**ADDENDA
00 91 13**

Mechanical Addendum #M-01

The information listed below is to form part of the Contract Documents. All associated costs are to be included in the Bid Price shown on the Bid Form. Acknowledgment of this Addendum, by number, is to be shown in the space provided on the Bid Form.

M4-01

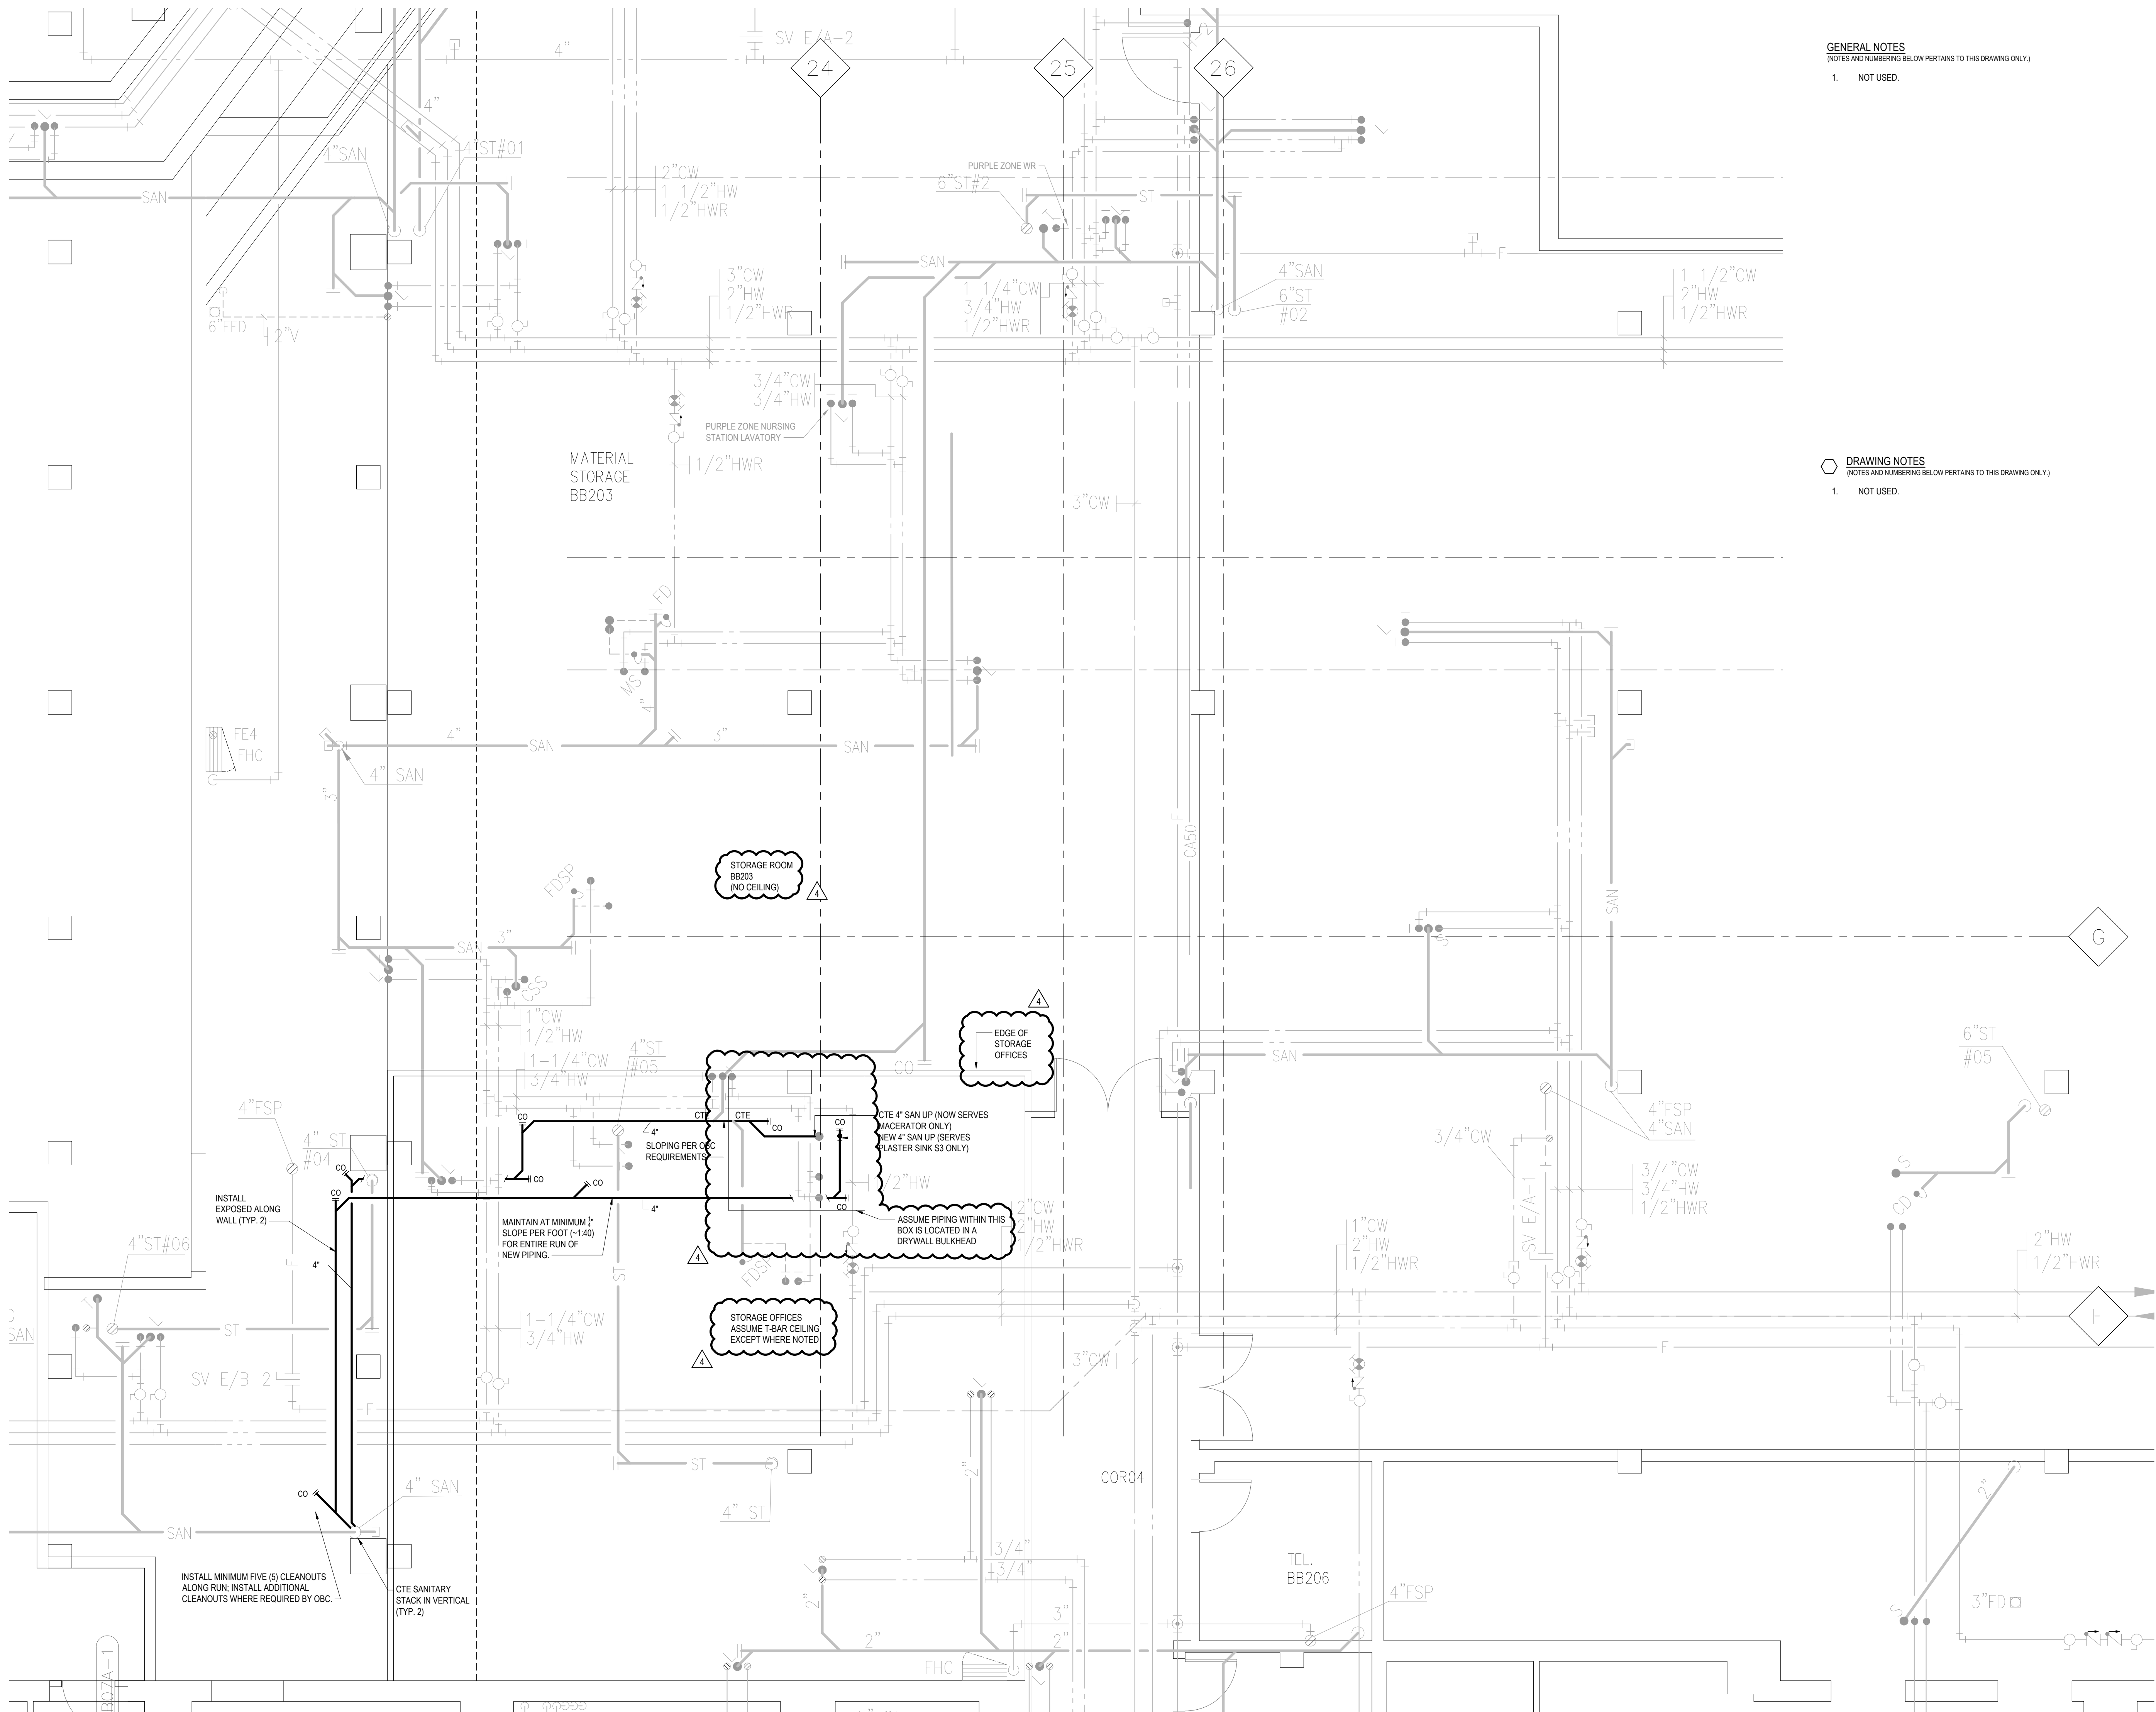
During the site visit, we were shown the basement area where the plaster sink is to be connected (refer to drawings M4-00 and M4-01). Some areas appeared to have suspended T-bar ceilings; however, we are unable to determine the extent and locations of these ceilings from the drawings provided. Please clarify the areas where T-bar ceilings exist and identify any ceiling removal, reinstatement, or access requirements necessary to complete the work.

3.12 Reference Drawing M4-01 - PLASTER SINK - BASEMENT PLUMBING - NEW WORK (reissued)

- .1 Clarified where piping is exposed within the Storage Room ceiling vs. where piping is located within an existing T-bar or drywall ceiling.

ANSWER: Refer to Drawing M4-00 and M4-01 as updated as part of this addendum.
